AMENDMENT NO 01. Dated 17.09.2026.
Tender No. GEM/2026/B/7989186

The following amendment to the Technical Specification of the Tender is incorporated.

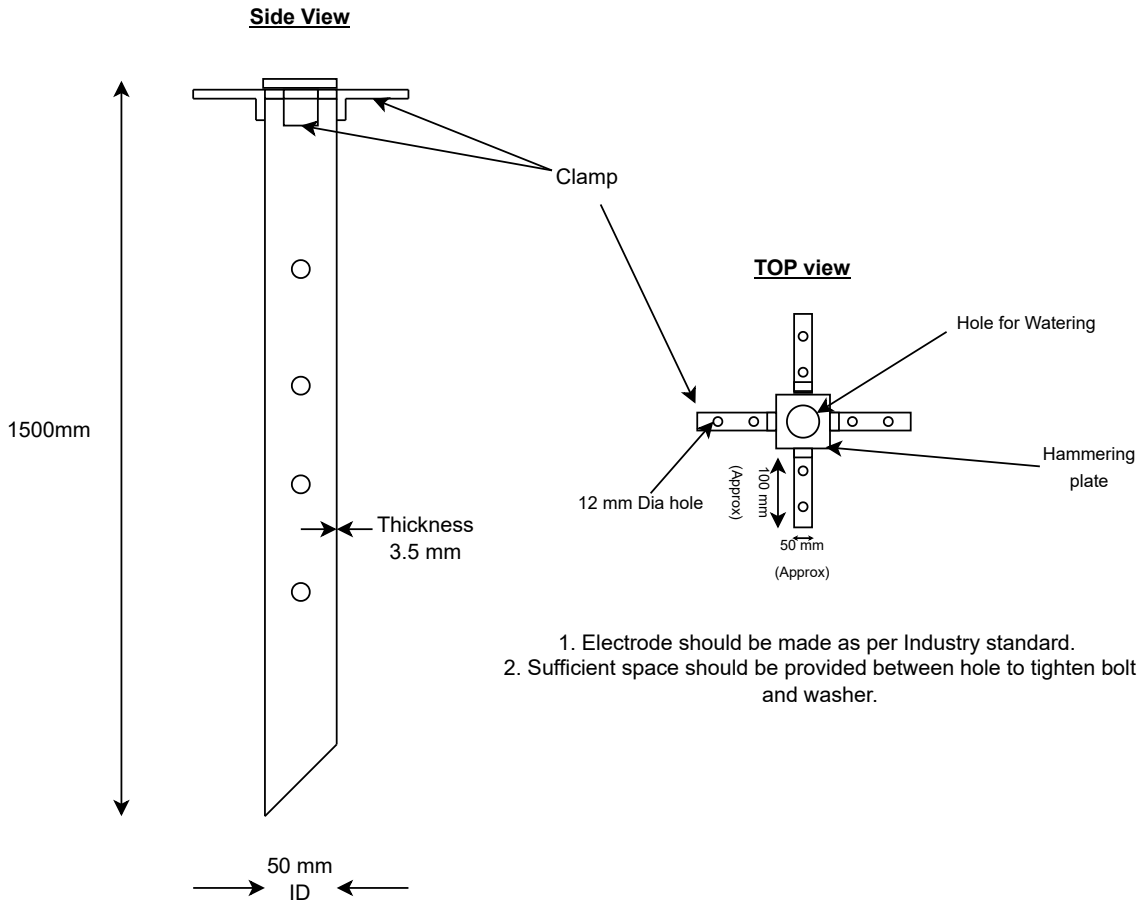
1. The earthing pipe shall have a wall thickness of 3.5 mm.
2. Details of Clamp: Each electrode shall have 4 numbers of clamps positioned at 90 degrees to each other. Each clamp shall be L-shaped and directly welded to the electrode. The top section of the each clamp should have dimensions of approximately 100 mm x 7 mm x 50 mm, with two holes (12 mm diameter) for the earthing bolt connection.
3. The Electrode should be fabricated from MS Pipe and galvanized after fabrication. This is to ensure all cut and drilled surfaces are fully protected against corrosion.
4. Dimensional details/drawings of the electrode shall be submitted along with the offer for scrutiny.
5. An indicative drawing of the earth electrode is attached for bidder's reference.

1. Electrode should be made as per Industry standard.
2. Sufficient space should be provided between hole to tighten bolt and washer.
